Re: Certificate of Appropriateness for 909-915 Jenifer Street

PLANNING DIVISION STAFF REPORT

Project Name & Address: 909-915 Jenifer Street

Application Type(s): Certificate of Appropriateness for an addition in the Third Lake Ridge Historic District

SITE PLAN PROPOSED

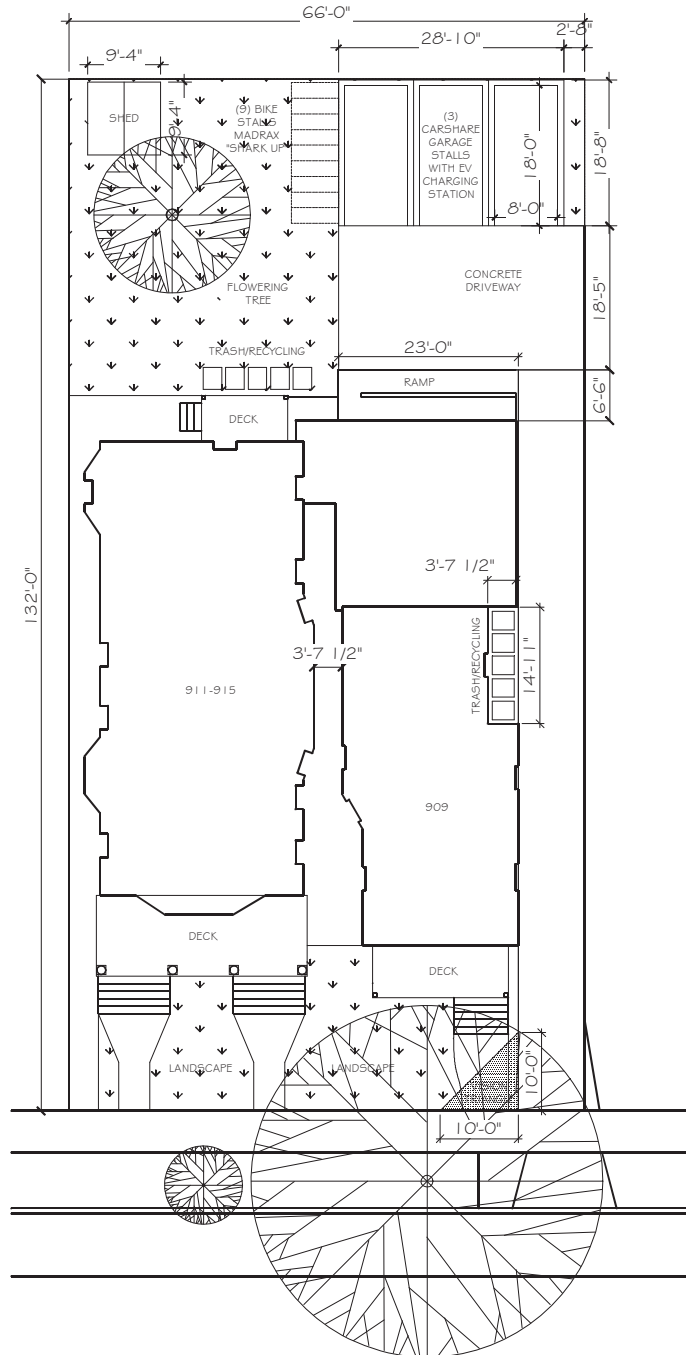
The basement-level connector will be minimally visible from the public right-of-way as the two buildings 3'-7" apart at their midpoints and 4' apart at the point of the proposed connection on the rear of the buildings. The connection is noted on the plans as a plinth. It is unclear how the plinth will appear above grade.

1. Door and window specifications
2. ADA ramp and railing design
3. Roof shingle specifications
4. Above-grade cladding or landscaping treatment of the plinth connector

No	Revision / Issue	Date

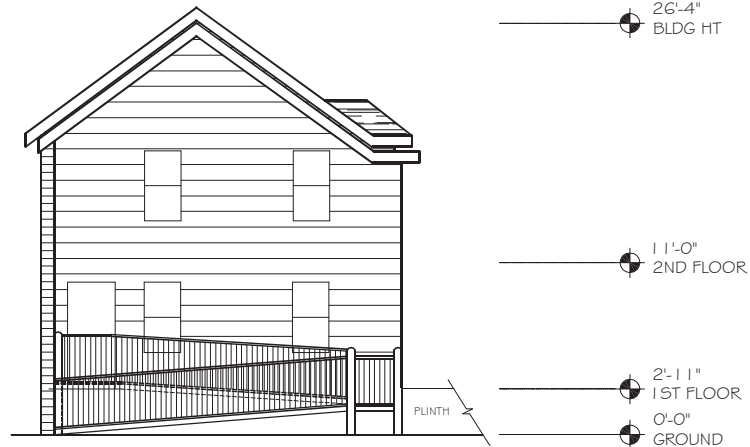
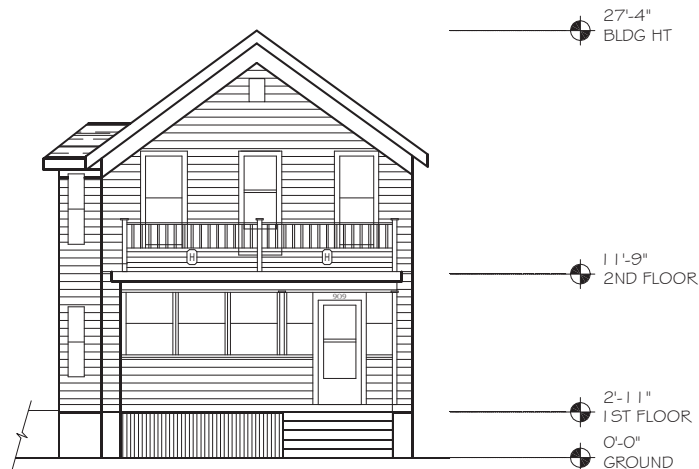
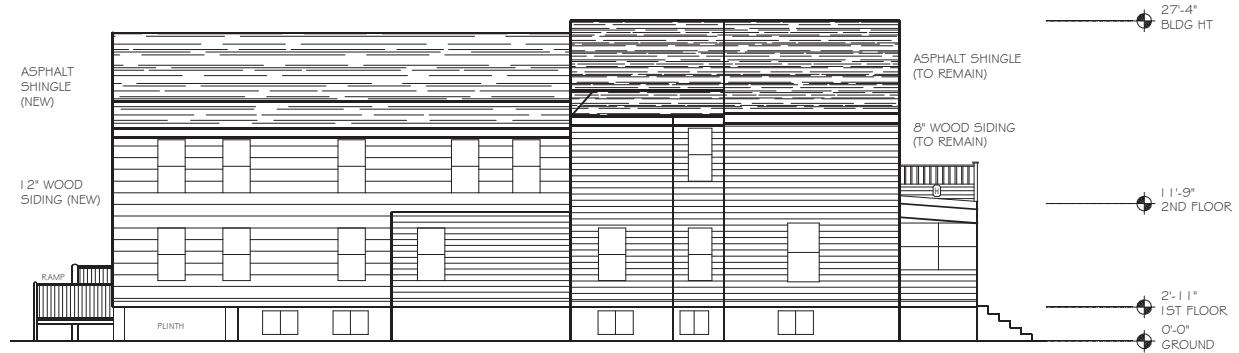
There is a discrepancy between the submitted plans, which show a 12" reveal on the clapboards, and the plans approved by the NPS, which show a 6" reveal. The 6" reveal would differentiate the historic from the new construction but be comparable to the historic resources. The 12" reveal would contrast with the historic resources.

1. The materials for the exterior cladding will be a 6-inch clapboard, which will be compatible with the historic 4" reveal clapboard on the historic structure.
